Access Compliance Report

Public Rights-of-Way

(Curb Ramps)

Intersection ID: 45733	Main Street: REDWOOD VALLEY LN	Cross Street: DALTREY LN	Location: SE
ADA ID: CAEC5E4F879D	Ramp Type: PerpDiag	Initial Pass/Fail: Fail	Overall Compliance: No
		Severity Score: 10

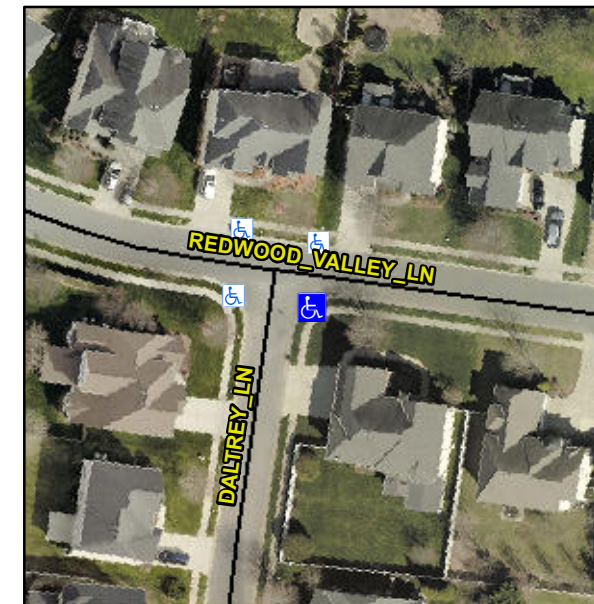
Not Found, R304.5.1, R304.5.3

Compliance	Description	Data	Compliance	Description	Data
N/A	Ramp Length (in)	48.0	Yes	Ramp Slope (%)	6.5
No	Ramp Width (in)	45.0	No	Ramp XSlope (%)	3.6
N/A	Flare Type LT	N/A	N/A	Flare Type RT	N/A
N/A	Flare Slope LT (%)	N/A	N/A	Flare Slope RT (%)	N/A
N/A	Flare Traversable LT?	N/A	N/A	Flare Traversable RT?	N/A
N/A	Landing Length (in)	N/A	N/A	DWS Provided?	N/A
N/A	Landing Width (in)	N/A	N/A	DWS Contrast?	N/A
N/A	Landing Slope (%)	N/A	N/A	DWS Length (in)	N/A
N/A	Landing X Slope (%)	N/A	N/A	DWS Full Width?	N/A
N/A	Landing Curb? (Y/N)	N/A	N/A	DWS Offset (in)	N/A
N/A	Shared Landing?	N/A			
N/A	Gutter Ponding?	N/A	N/A	Gutter Slope (%)	N/A
N/A	Gutter Lip Ht (in)	N/A	N/A	Gutter X Slope (%)	N/A
N/A	Painted X Walk1?	No	N/A	Painted X Walk2?	No
	X Walk 1 Direction	To NE		X Walk 2 Direction	To NW
N/A	X Walk 1 Width (in)	N/A	N/A	X Walk 2 Width (in)	N/A
	X Walk 1 Slope (%)	1.4		X Walk 2 Slope (%)	1.7
	X Walk 1 X Slope (%)	1.0		X Walk 2 X Slope (%)	0.1

Remove & Replace Curb Ramp With Two New Directional Ramps or Equivalent.
